Agenda

Council Meeting

7.00pm, Tuesday 1 June 2021

This report provides Council with an assessment of an application to amend Planning Permit PLN17/0703 at 640 Heidelberg Road, Alphington against the provisions of the Alphington Paper Mill Development Plan 2016 and the Yarra Planning Scheme.

Figure 17 – Civil Building proposed amendment (left) and current amendment (right)

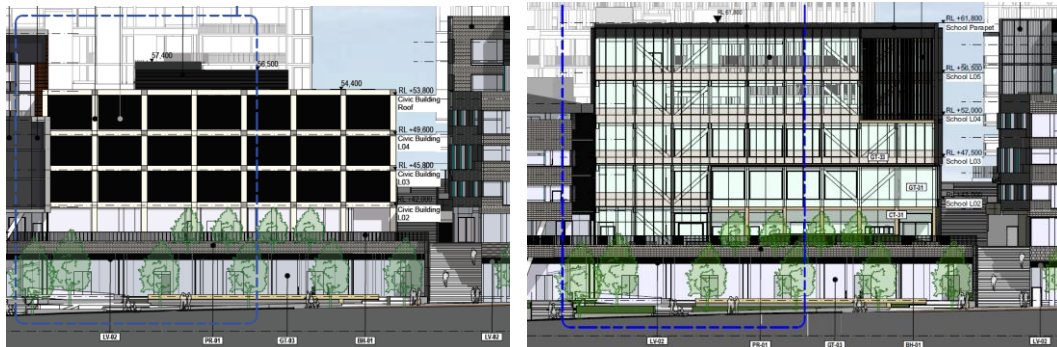
187. The current application seeks to reduce the height of the Civic Building, west of the Village Square by one storey (from 7 to 6 storeys), thereby having a reduced visual impact. This reduction in height will still present a well-articulated building interfacing with the Village square. This is also supported by the external urban design advisor, who was satisfied that *‘...it remains tall enough to contribute to the framing of the Village Square.’*

Figure 24 – proposed construction outside title boundaries (boundary dashed in red)

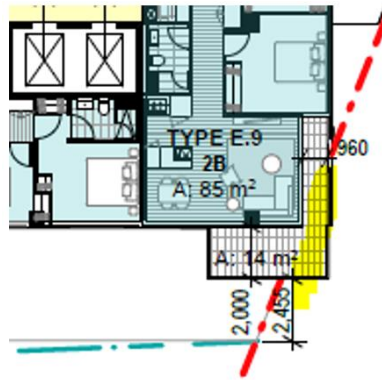
200. At the south-eastern corner of Mills Boulevard and Nelmoore Lane, a taller building element is proposed to 'mark the corner'. It is noted in the Built Form and Interfaces diagram (highlighted in the image below) depicts the 'above podium' extending to the corner at that point. In this regard, the proposed amended design response is considered in accordance with the DP. However, as illustrated in Figure 24 below, this projecting element extends beyond the title boundaries, which includes a section of the balcony. Construction of trafficable areas outside title boundaries is not supported. To address this issue, a condition is recommended that the corner is amended to ensure that the balconies, and the roof plant enclosure, does not project outside title boundaries.

Figure 26: Northern Elevation of South-West building

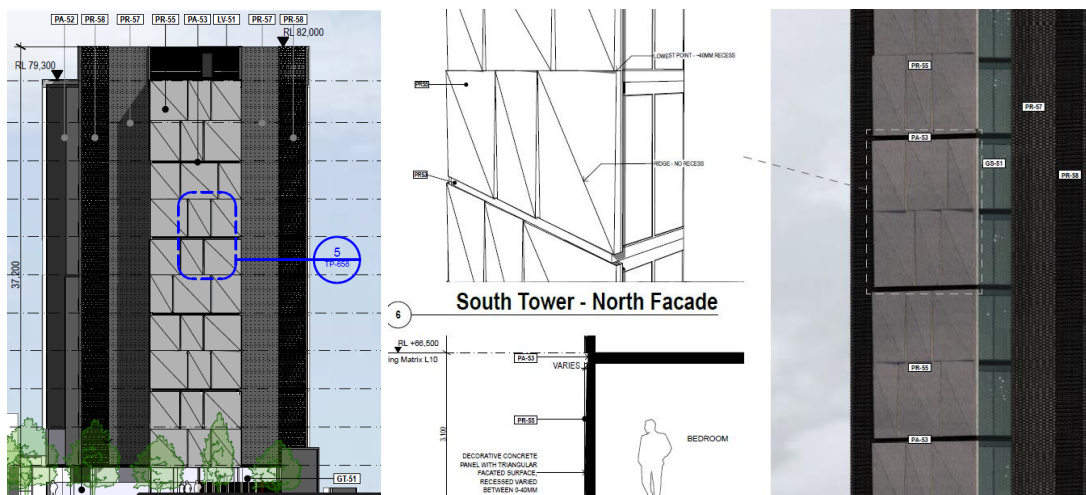
209. It is recommended that angled concrete panels are increased to a minimum rebate of 150mm. Additionally, it is also required that this wall is further punctuated with glazing to each level. These recommendations have been included as amended conditions within the recommendation.

Figure 27 – Original proposal (left) and cinema screen wall of current amendment (right)

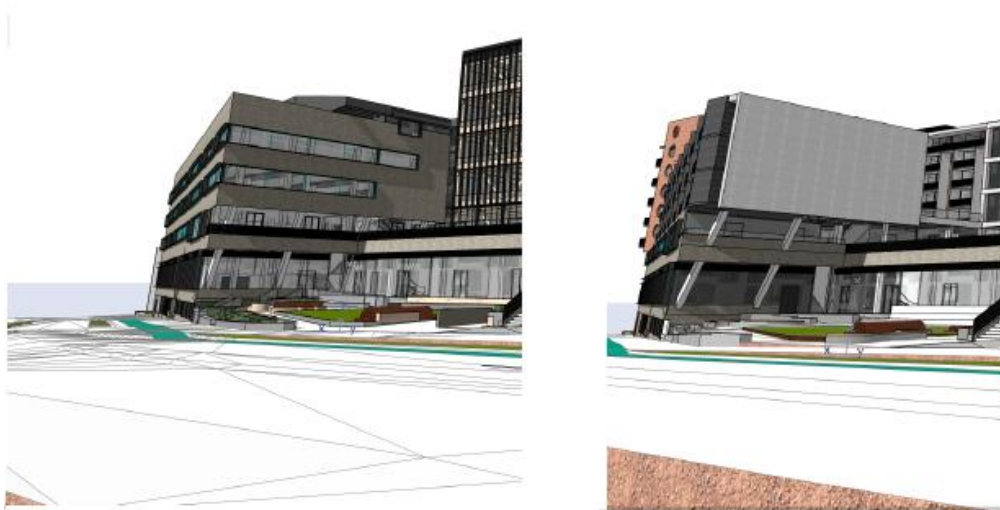
210. A sheer wall has also been introduced to the northern wall of the East Building, south of the Village Square, as illustrated in Figure 27 below. The purpose of this sheer surface was to provide for a retractable 'cinema screen' on this wall. As previously discussed, the cinema screen is to be deleted via condition. However, concerns are raised regarding the lack of articulation to this wall, with Council's external urban designer noting:

211. The permit applicant has offered a solution via 'sketch plan' received 7 May 2021, to break-up this wall as illustrated in Figure xx below. However, as will be discussed later, a separation condition is recommended to introduce operable glazing to this wall for the purpose of providing additional natural daylight and ventilation in the communal corridors of the East Building. Therefore, rather than adopting the alternative design for this wall, a condition will require additional articulation to be provided, including the provision for windows to the common corridors.

Figure 38 – 9m Overlooking diagram

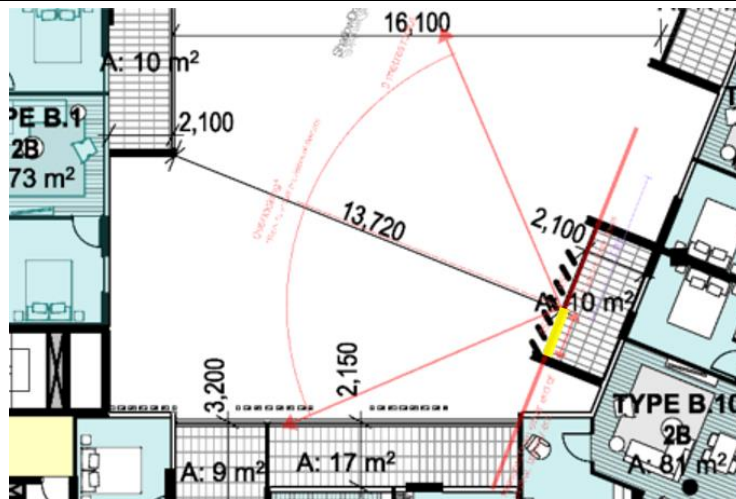
241. The proposed East apartment building appears to have angled screens to one of the balconies to prevent overlooking opportunities in the elbow of the building. This is supported as the screened balcony will continue to have an outlook to the north-west, however, the extent of screening to the balcony is greater than necessary to prevent views into the balconies to the south-west. As illustrated in the diagram below, views beyond the first three angled screens are over 9m from the adjacent balconies and are not required to be screened to prevent overlooking. Accordingly, the screening could be reduced, which would further improve the outlook for this apartment. This will be conditioned accordingly.

Figure 44: PLN17/0703 Architectural Plans Drawing No. TP-503 (left) and PLN18/0173 Aspect Studio Landscape Plans for Artisan East- M17038-LA-702 (right)

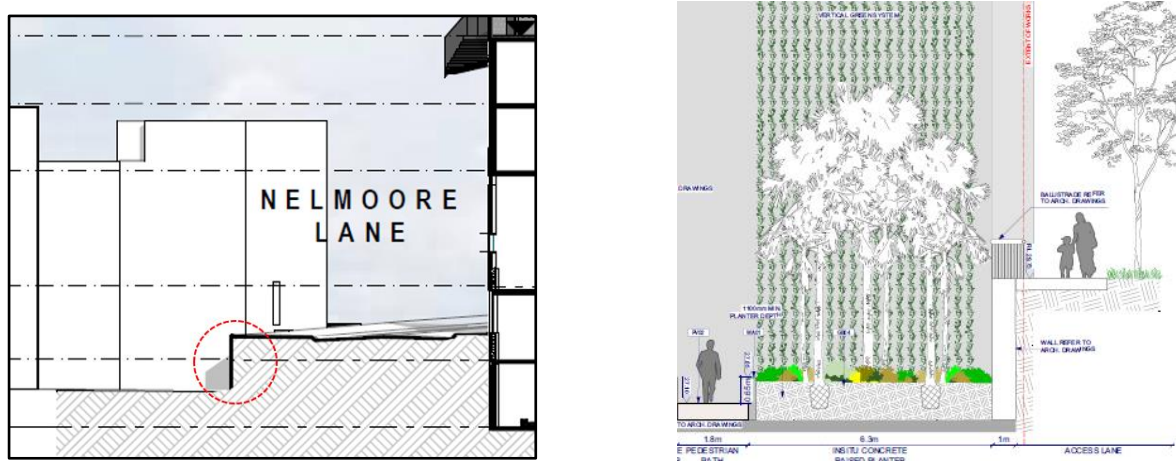
286. Council's Engineering Services Unit has also identified a significant level change that is occurring along Nelmoore Lane. It is clarified that this is the section of land adjacent to the Hub building. A balustrade is proposed along this interface as illustrated in the landscape plans for PLN18/0173 (Artisan East).

Figure 46 – south-western stairwell of the eastern apartment building

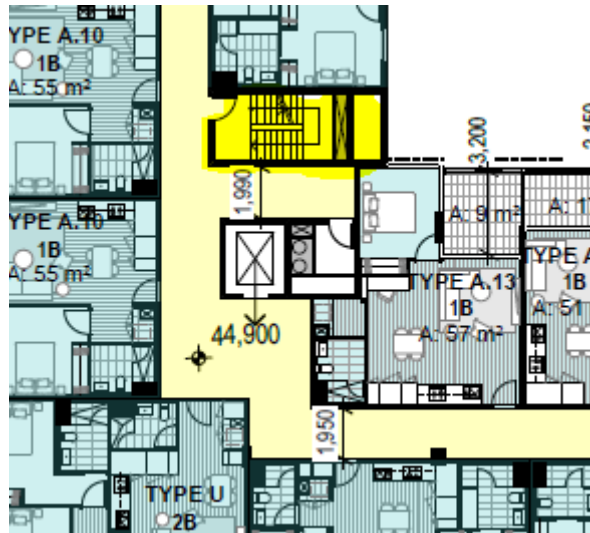
327. Level 2 will receive reasonable natural light via the central main lobby and a second lobby at the north-eastern end. Levels 5 to 7 will receive natural light from a window adjacent to the central lift core. It is unclear whether the windows to these levels will be operable. To provide an opportunity for natural ventilation, a condition of permit will require the windows to these areas to be operable. The internal corridors on Levels 3 and 4 do not provide any natural daylight or ventilation. To introduce natural light into these levels, it is recommended that stairwell near the south-western lift core (shown in Figure xx) is glazed to the south, west and external eastern sides. This will also provide greater visual permeability within the corridor leading to the bin chute room, resolving a potential concealment area. Additionally, it is recommended that the corridor could be extended to the north-eastern end to provide glazing and natural ventilation opportunities. This is illustrated in Figure xx below. This amendment would require the layout of apartment on the western side of this corridor. It is recommended that these modifications are implemented via additional conditions on the amended permit.

Figure 49 – Apartment type A15, dimensions added by Council officer.

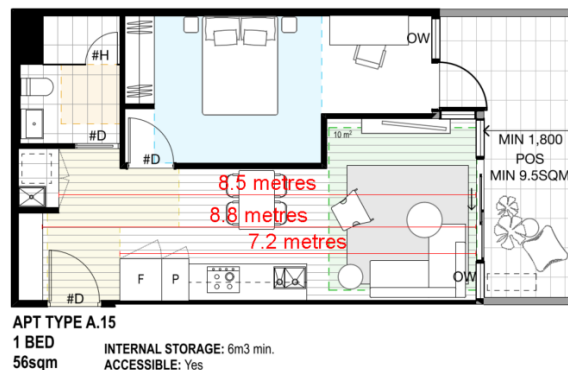
373. The only habitable rooms that exceed a depth of 6.75m relate to living areas. In these cases, the kitchen is located the furthest from the window and the depth of the room does not exceed a maximum depth of 9m in accordance with Standard D25. The exception to this is single bedroom Apartment Type A15, which has been introduced as part of the current amendment. The clause 58 table identifies this apartment as having a maximum depth of 9.5m, however, based upon officer assessment, the maximum depth of the room is 8.8m. Additionally, this also includes a cupboard, European laundry cupboard and apartment entrance area at the far end of the room as illustrated in the image below. It is appropriate to exclude these areas from the area intended as the main living area, which is considered to cease at the end of the kitchen, which is illustrated below as having a maximum dimension of 7.2m, consistent with Standard D25. Based upon the officer assessment, the proposed amendment is considered to continue to comply with this standard. To ensure that this is accurately reflected in the Clause 58 compliance table, a condition of permit will be required for this table to be updated to accurately reflect the dimension of the main living area excluding the entrance, laundry and storage areas i.e. 7.2m.

Figure 50: Apt Type D.1, with additional dimensions added by Council officer.

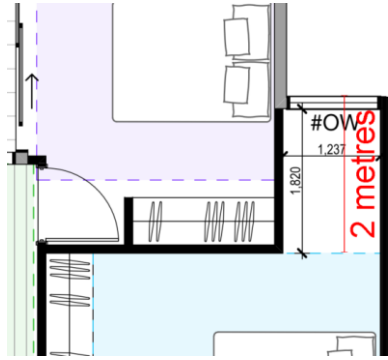
375. The previous amendment included two apartment types (Type D & L) with a second bedroom receiving daylight from a smaller area. The current amendment has added 5 new 'D-type' variations with this saddle-back arrangement. This is permitted under Standard D26 provided that the secondary area is a minimum width of 1.2m and a maximum depth of 1.5 times the width, measured from the external surface of the window. Apartment types D & L complied (and continue to comply) with this requirement. New apartment Type D.5 is shown to have a width of 1.237m and a depth of 1.82m, however the depth is taken from inside the window, rather than the external surface. Taken from the external surface of the window, the maximum depth is approximately 2m. This does not comply, with Standard D26, which requires a maximum depth of 1.855m (i.e. $1.5 \times 1.237 = 1.855\text{m}$). Apartment Types D.1 and D.2 may also not be compliant. A condition will require full compliance with Standard D26 (windows), with room extension depths measured from the external surface of the window.

Figure 51 – anomaly carparking spaces on Lower ground floor plan

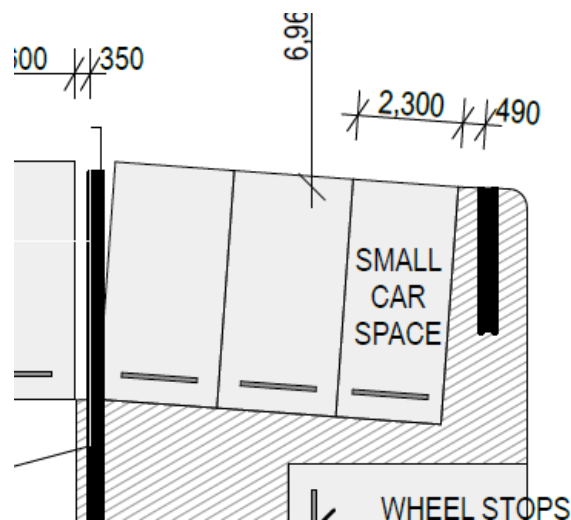
- (a) *Lower ground basement to be extended to accommodate any additional car parking as a result of a loss of car parking elsewhere.*
414. It appears a drafting error may have occurred on the Lower Ground plan with a set of 3 spaces now shown on an angle, with the westernmost space shown cutting into the wall (see Figure below). A condition will be added to address this anomaly if an amended permit is to issue.

Figure 52 – excerpt from Strategic Transport referral advice depicting door obstruction

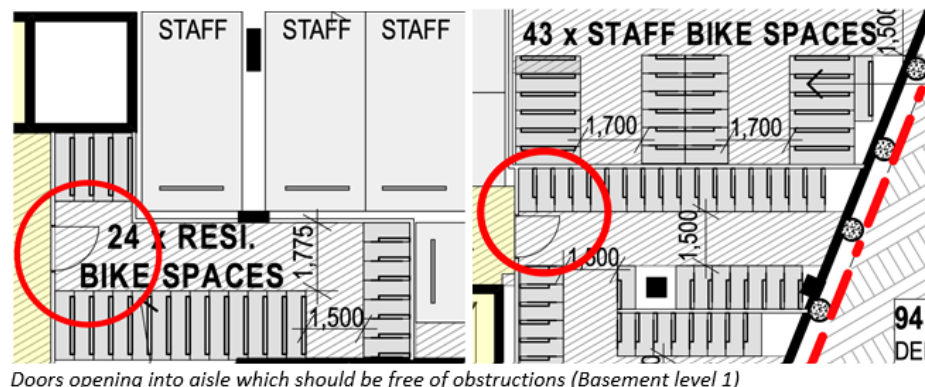
421. The layout and design has also been reviewed by Council's Strategic Transport Officer, who is satisfied that AS2890.3 has been met, however has identified that the doors to the secure bicycle storage areas on Basement 1 has a door opening into the bicycle area, resulting in an obstruction with the aisle (as illustrated in the image below. It is requested that the doors be amended accordingly. This will be addressed by condition the amended permit, if one is to issue.

Figure 54 – Community Facilities layout in current amendment

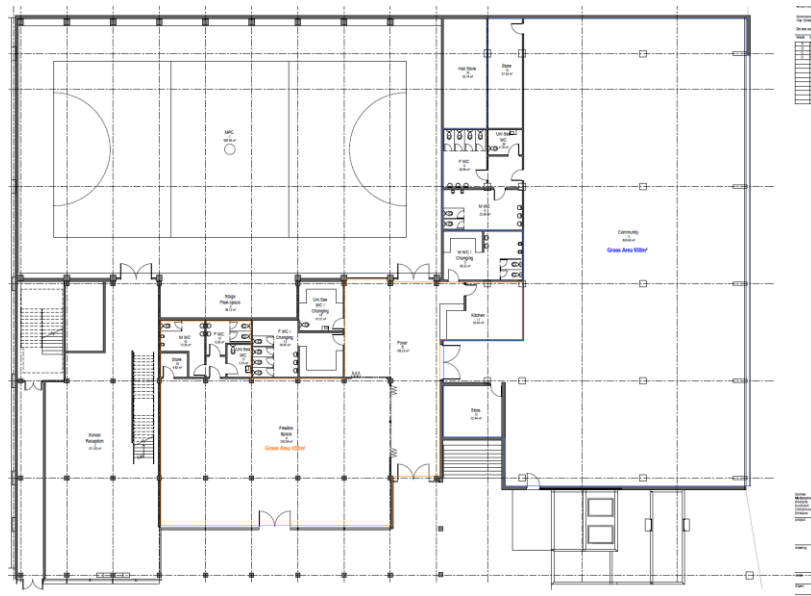
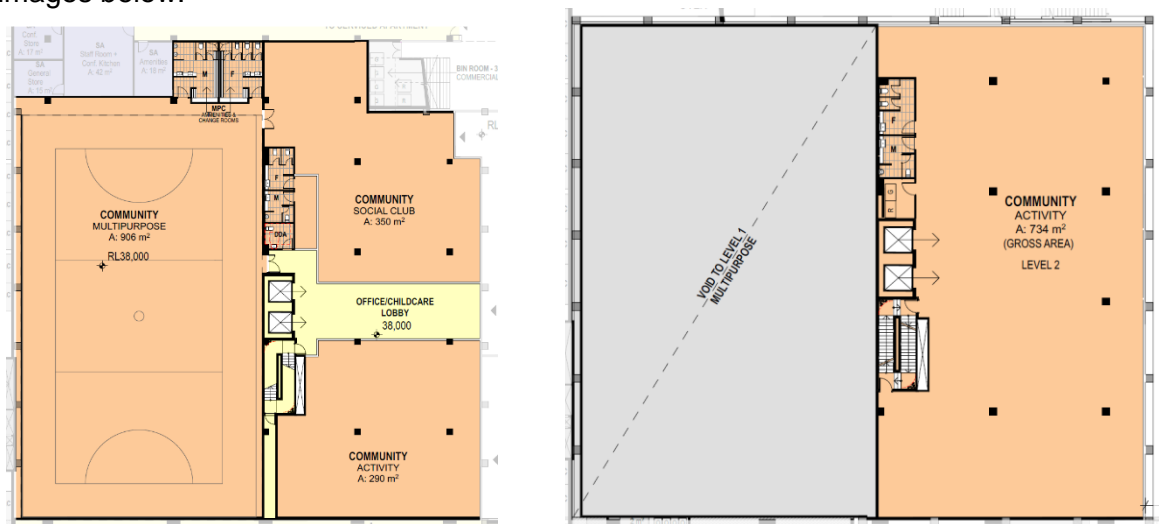
428. The larger of the community spaces (i.e. the “warm shell”) was reduced in area, falling short of the December 2015 resolution by 462sqm. However, the increased functionality of the indoor multipurpose court was considered to offset the loss in area from the community space. Additionally, the smaller community space area was proposed to be increased from the Council resolution from 300sqm to 432sqm, thereby increasing the potential capacity of this area.

429. The amended layout of the community activities also resulted in other improvements to the original design. In particular, the larger community space was relocated from centrally within the site, with limited access to windows for daylight and outlook, to instead face Heidelberg Road. This provided substantially improved access to daylight and outlook to this space. Furthermore, the smaller community space was reorientated to extend lengthways adjacent to the Level 1 podium landscape area, also enhancing the outlook and daylight opportunities to this space.
430. As a result of the current amendment, the layout and design of the community facilities has been further modified and is now proposed to extend across two levels as shown on the images below.

- (bb) *Community Facilities on Level 1 to be shown in accordance with the Architectus Plan Drawing DA1010 dated 18 October 2018 but further modified to show/include:*
 - (i) *Gross Floor Area of the 'Community 3' space ("warm shell") increased to a minimum of 1,000sqm;*
 - (ii) *Roller door provided from 'Hall Store 18' to the stadium ('MPC 1');*
 - (iii) *Rename the 'Community 3' space as 'Warm Shell' and 'Flexible Space 4' as 'Community space';*
 - (iv) *Extend the northern wall of 'Store 12' to the column to the north (i.e. to align with Kitchen 11);*
 - (v) *'Store 12' divided to serve both the 'Community 3', and the 'Flexible Space 4', including provision for a door to the foyer and a dividing wall;*
